LIGO-T1000558-v2

OUTPUT FARADAY ISOLATOR TABLE

As per LIGO-D0900015-v4 the bench as become a lightweight version of its former self i.e. LIGO-D0900015-v3.

LIGO-D0900015-v4 (shown upside down with cut-out pockets shown.)
LIGO-D0900015-v4 now weighs 2.8 kg cf. LIGO-D0900015-v3 which weighed 7.7 kg.

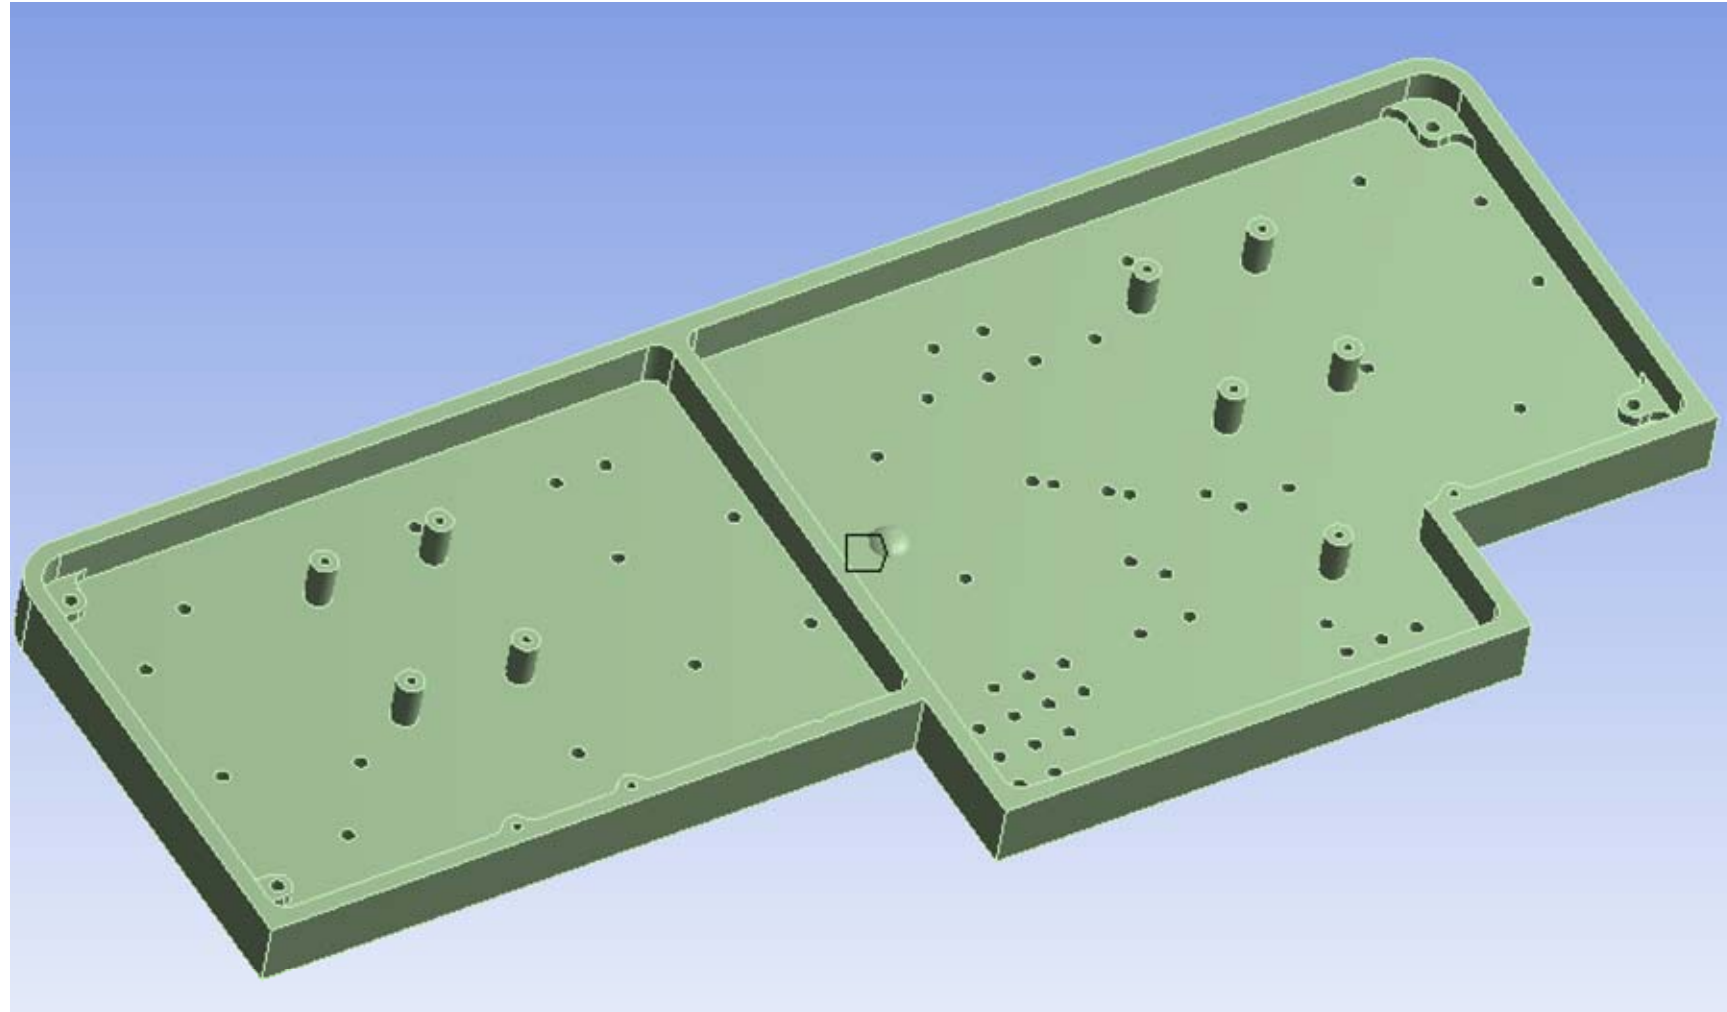
This change occurred with no ECR or DCN to go along with it.

As stated above no ECR or DCN goes along with LIGO-D0900015-v4. The only statement on the DCC is as follows "Reduced table plate weight by machining pockets from bottom surface. TQ. Nguyen, 02 Nov 2012."

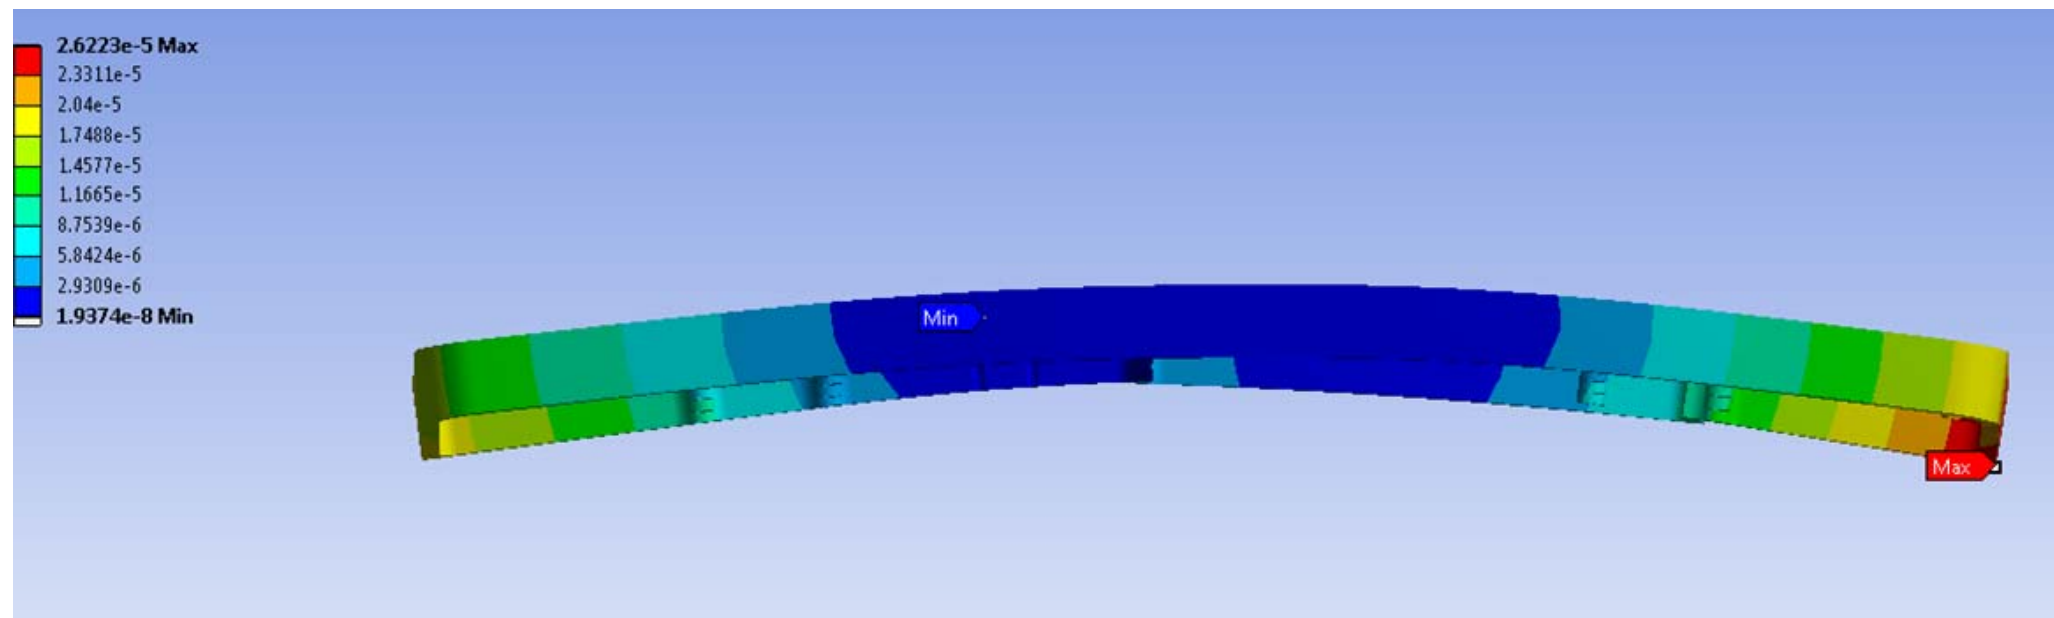
STATIC DEFLECTION UNDER GRAVITATIONAL LOAD WITH THE 4 WIRE SUPPORT POINTS PINNED. THE MAXIMUM DEFLECTION IS 2 MICRONS. FAR LESS THAN THE 1 MM ALIGNMENT TOLERANCE. ALIGNMENT ON A BENCH WILL NOT CHANGE SIGNIFICANTLY WHEN SUSPENDED DUE TO TRANSLATIONAL DEFLECTION.

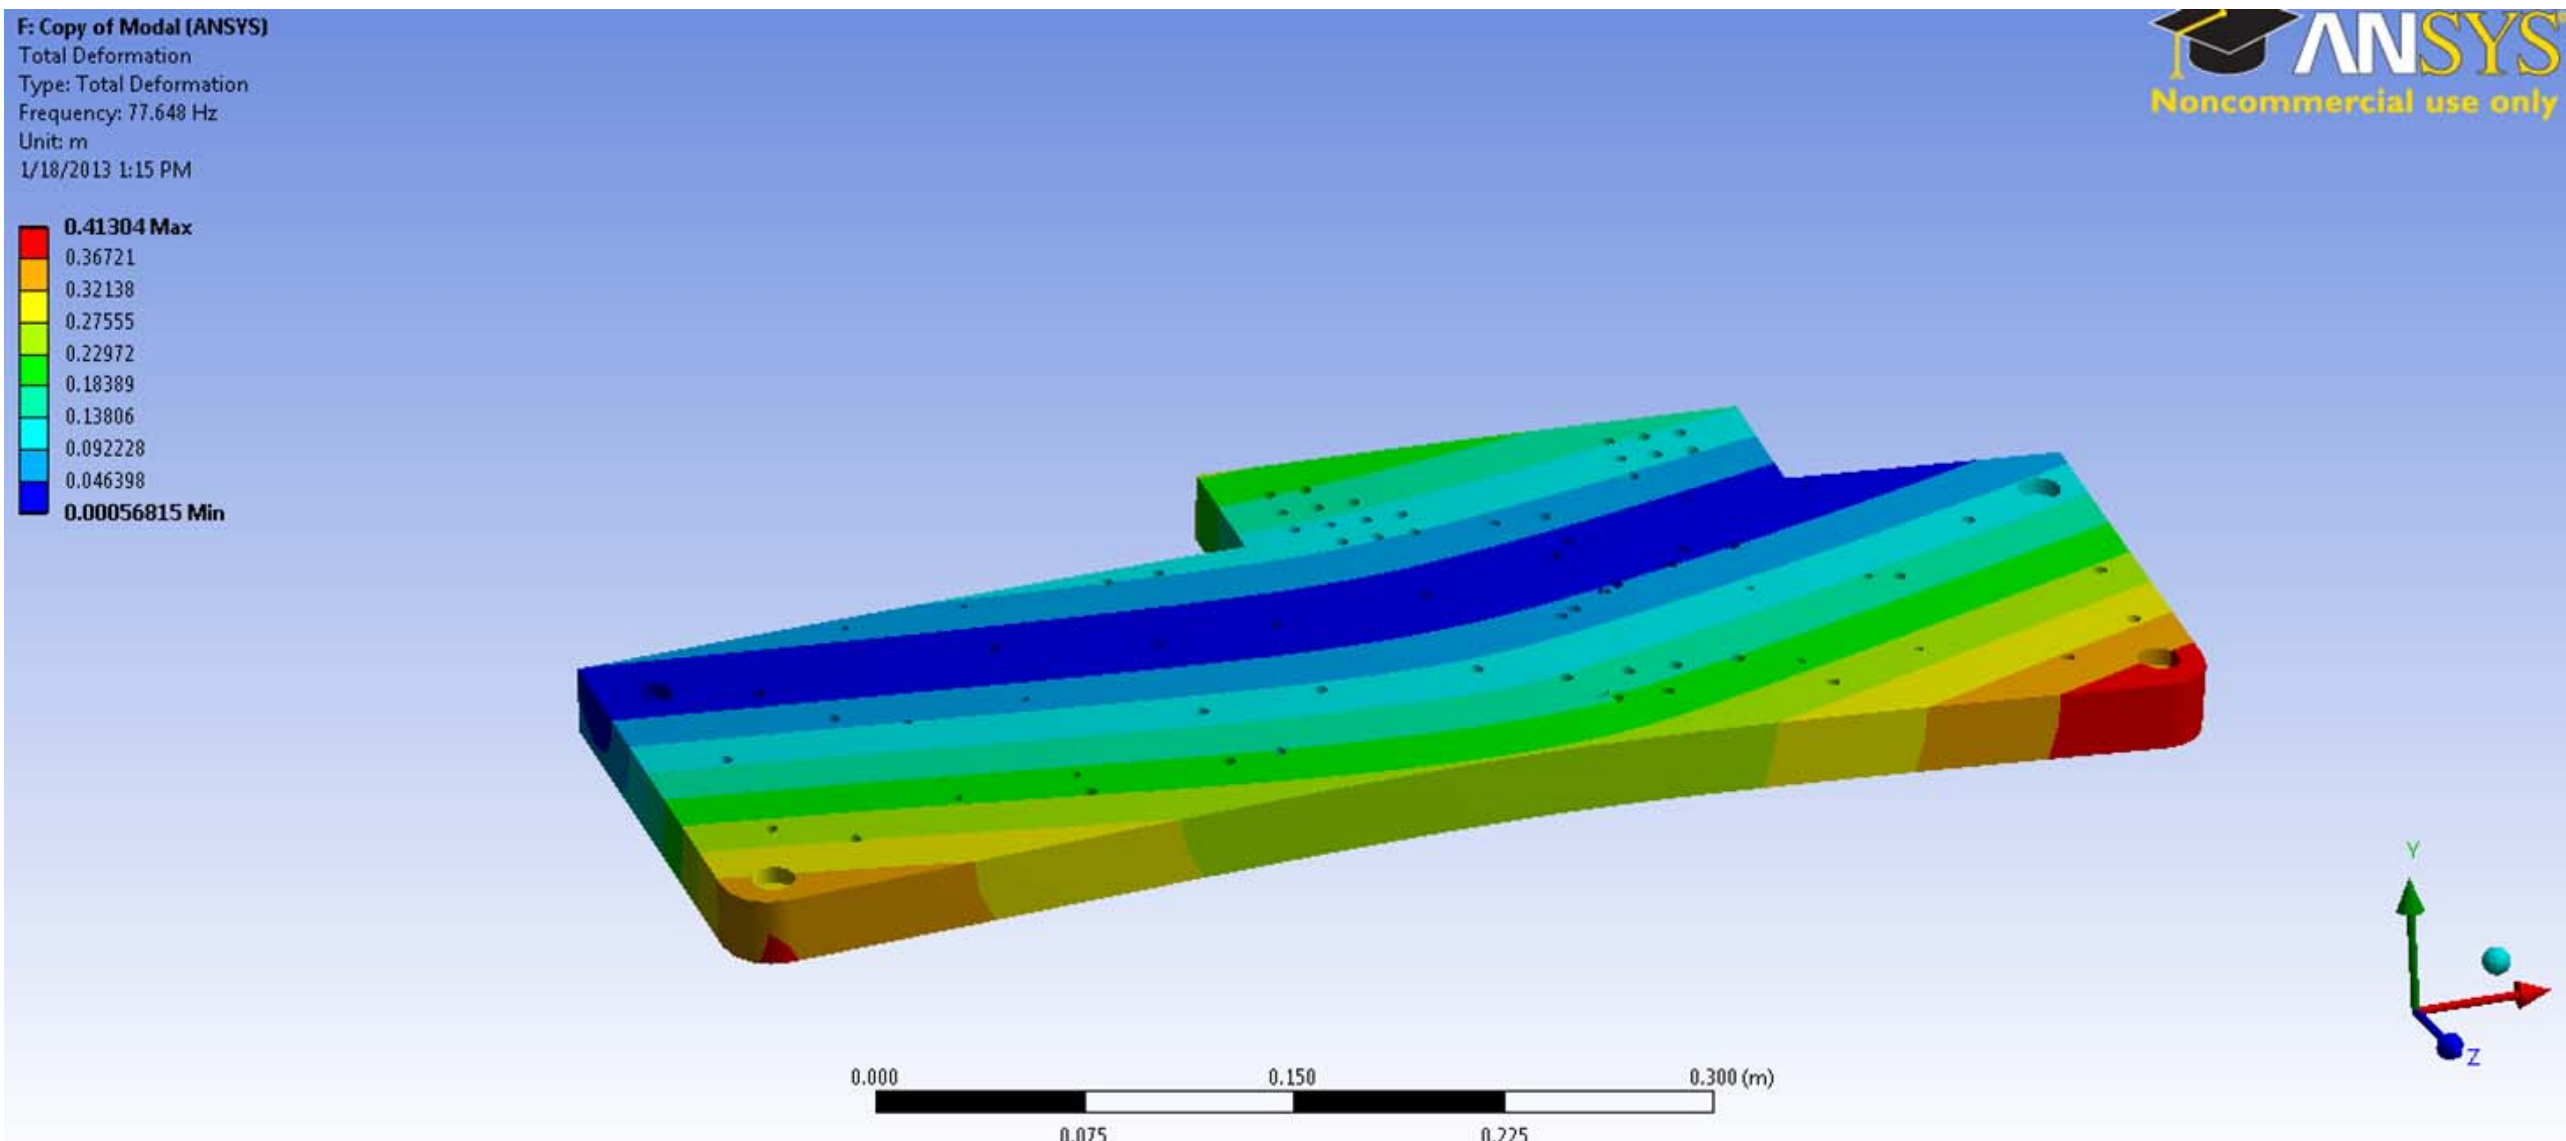
Finite Element modal analysis result is 77 Hz for the first frequency cf. 318 Hz with the original model using LIGO-D090015-v3. (Refer to page 4 for original work on modal.)

Mode Number *	Mode Frequency (Hz) *
1.	77.648 (shown)
2.	116.6
3.	128.34
4.	134.57
5.	159.83
6.	189.67

As per page 8 the updated Finite Element modal analysis result is 77 Hz for the first frequency cf. 318 Hz with the original model using LIGO-D090015-v3. (Refer to page 4 for original work on modal.)

How this could affect the performance of the bench is still an open question??

The B&K measurements in T1300042 indicate a bench resonance of 26 Hz. This could be the resonance the updated FEA measured at 77 Hz. The reason for the large discrepancy between this updated FEA and the experiment could be down to inaccuracy in the model caused by the fact we are modeling a thin plate with a large number of discrete mass distributed at specific points
